RESOLUTION NO. 15-20

A Resolution of the Fairfax Planning Commission Approving the Use Permit for a Restaurant with Indoor and Outdoor Seating, Design Review, and Sign Permit to Allow the Operation the Station Restaurant at 2001 Sir Francis Drake Boulevard

Subject: Review of Preliminary Plans for Restaurant at 2001 Sir Francis Drake Boulevard

① SITE PLAN
EPAID 1/15/1900

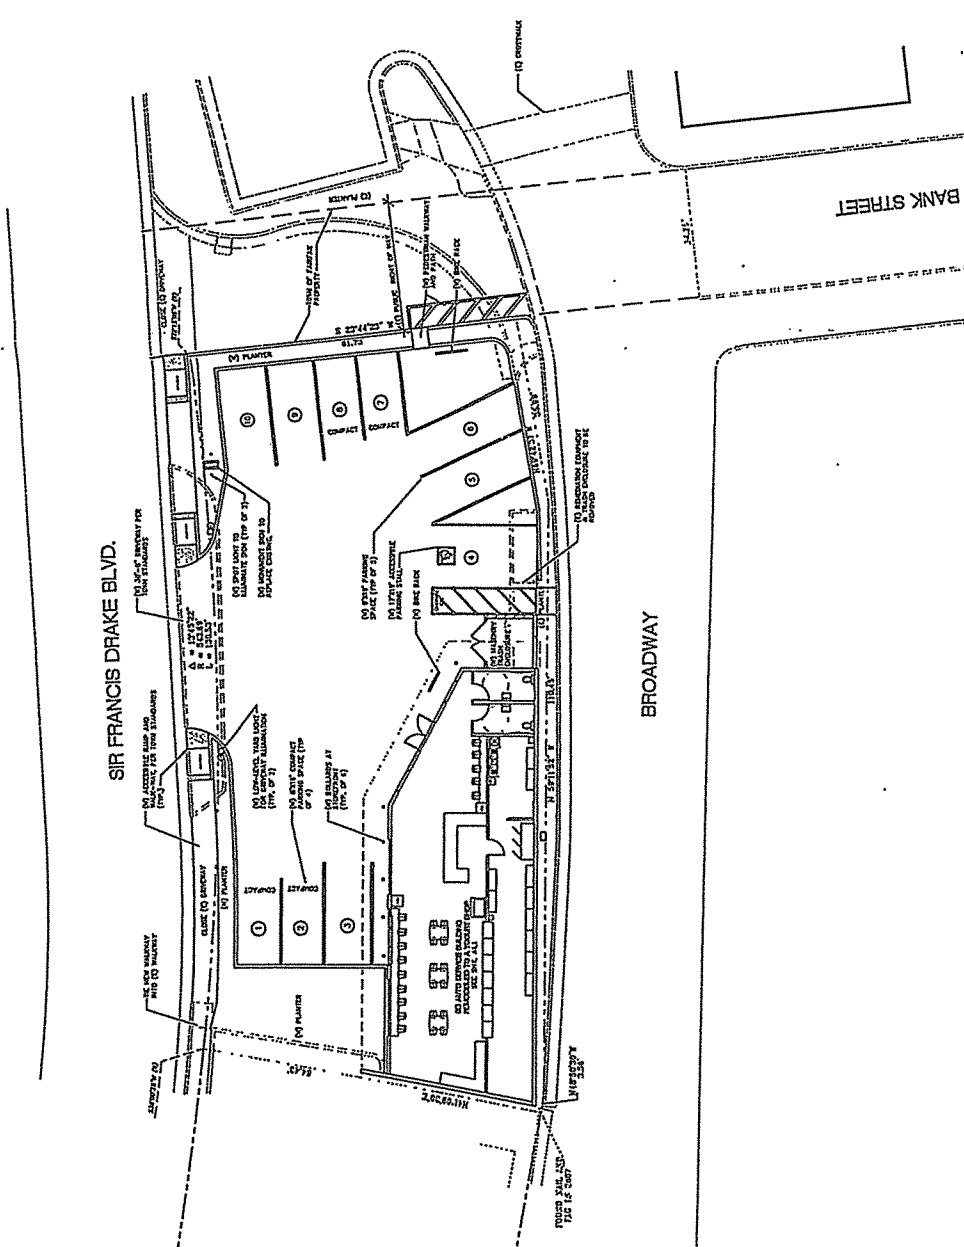
- The site plan indicates the provision of 9 parking spaces exclusive of a separate loading area. Based on Town standards, however, 10 on-site parking spaces would be required, up to 25 percent of which could be compact spaces. It is likely that parking demand for a 100-person restaurant would generate demand for more than 9 vehicle parking spaces, even when considering the proposed bicycle parking plaza. If parking demand cannot be met, some drivers may enter a full parking lot and turn back out of it to seek

- Town standards also require a 12-foot by 45-foot loading space, separate from parking area, be required. The submitted plan assumes small truck loading within the parking aisleway, with turning maneuvers accommodated within the lot by assuming no vehicles would be parked within the proposed 9 parking spaces. The project applicant claims that all loading would be completed during off-hours when no vehicles, including employee vehicles, are parked within the lot.

The Station will have an operational plan in place that does not allow larger trucks and keeps the parking lot open during early morning delivery hours. As proprietors who live two blocks away we can receive deliveries and also not take up parking spots. There is no dedicated employee parking, and we will be offering employees cost-saving benefits for utilizing public transportation and bicycling.

Figure 1 – Residual Hydrocarbon Impact Areas
Figure A1.00 – Site Plan [For Planned Redevelopment]
Appendix A – Agency Notification of Intent to Close Case, March 25, 2015

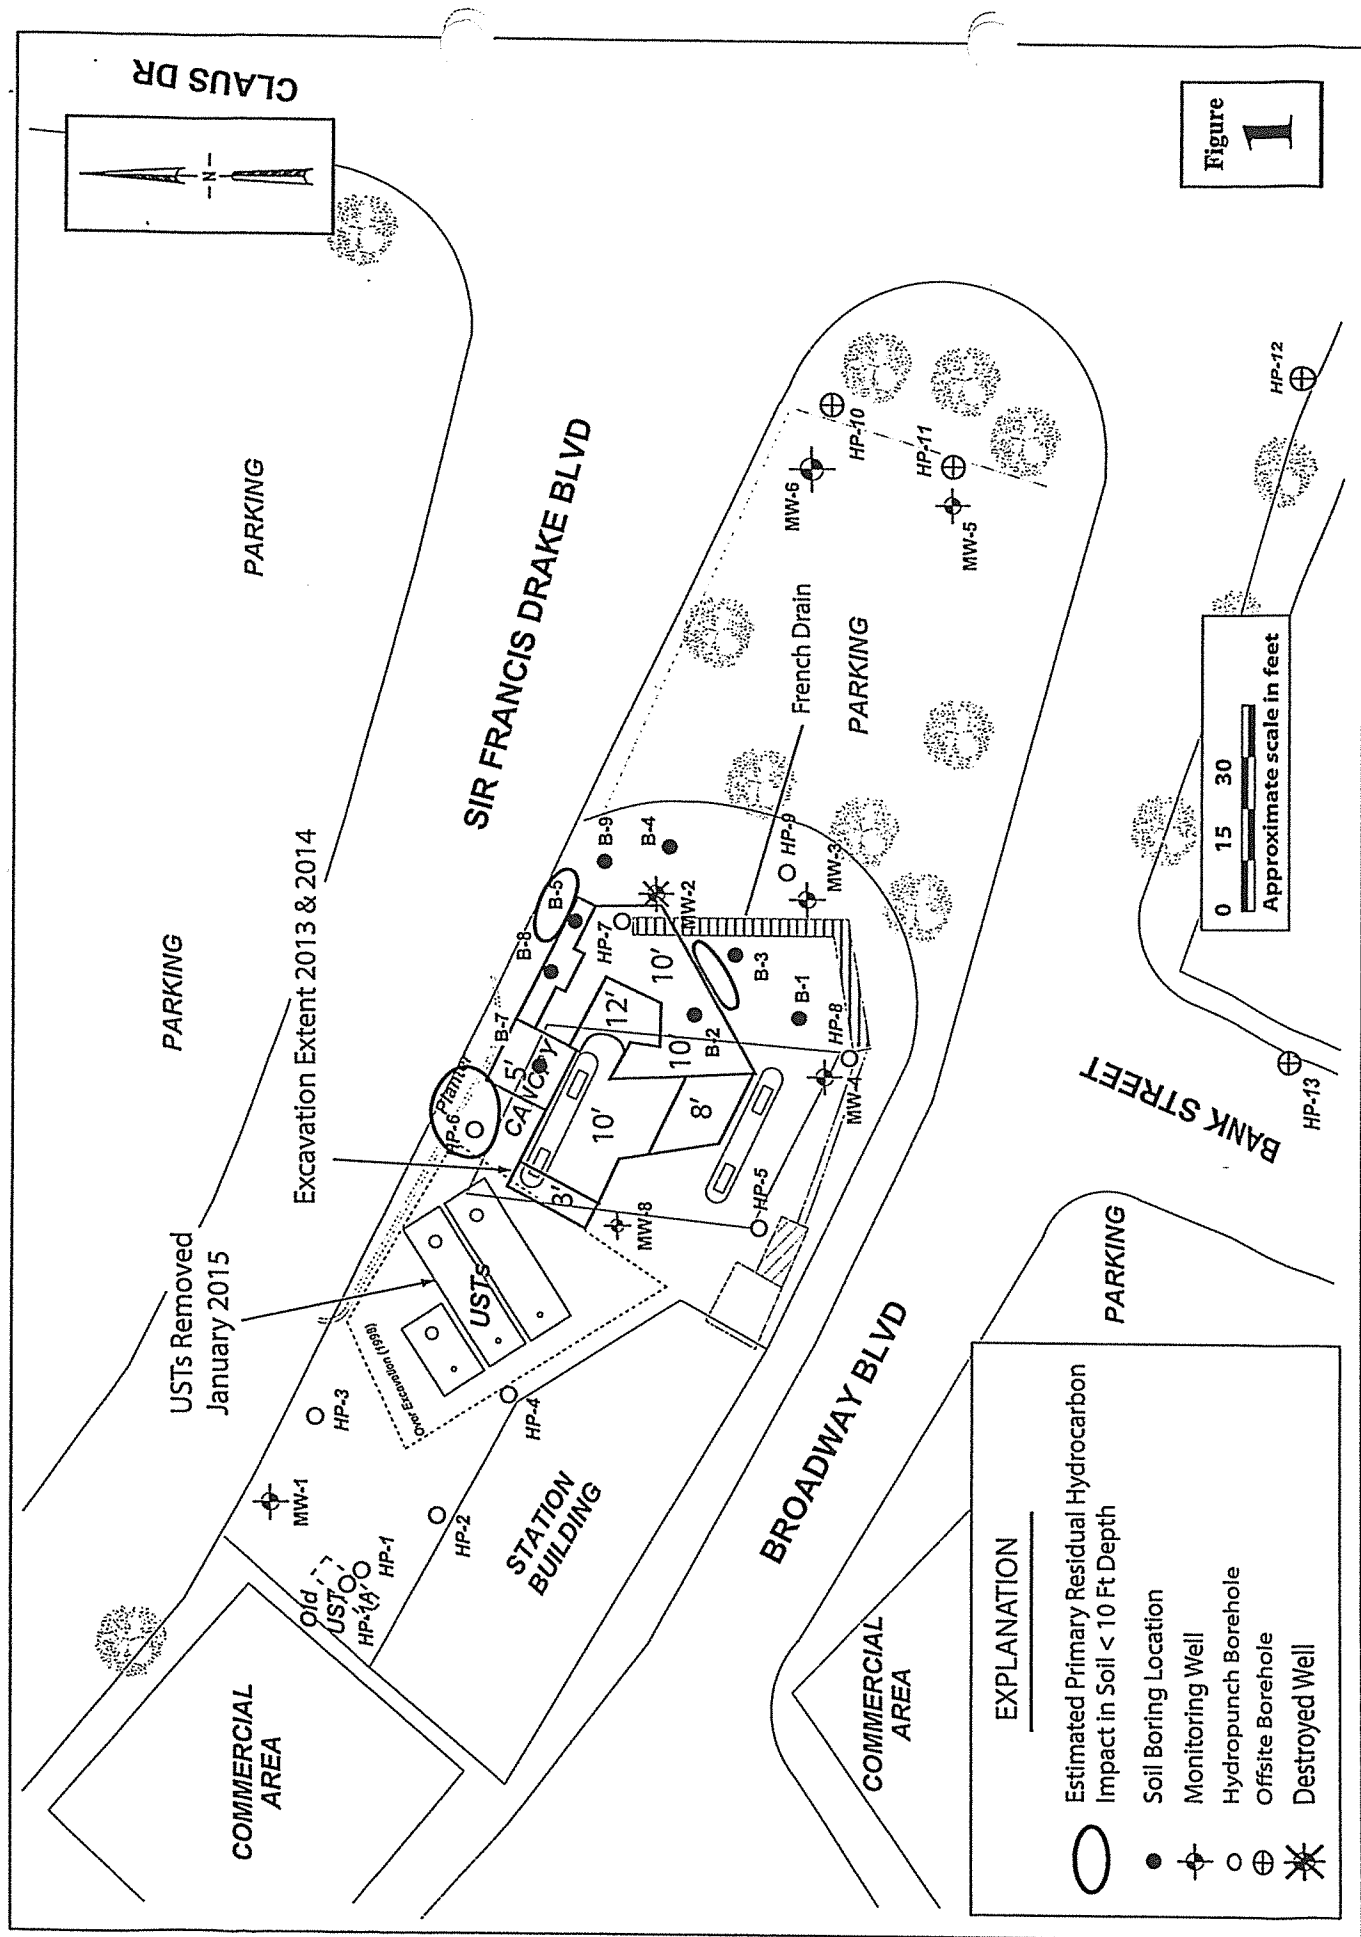
- Residual soil impact is primarily present adjacent 2001 Sir Francis Drake Boulevard, in deeper soil under the bottom of the former excavation, and at one limited area 5 ft depth at the southeastern boundary of the former excavation. This impact shown on Figure 1 is below LTCP criteria and does not merit further action. As shown on the planned development Figure A1.00, the residual impact is located in outdoor areas that will be covered with pavement. As shown on Figure A1.00, the impact is beneath the planned BBQ grill, bicycle rack, and planter.
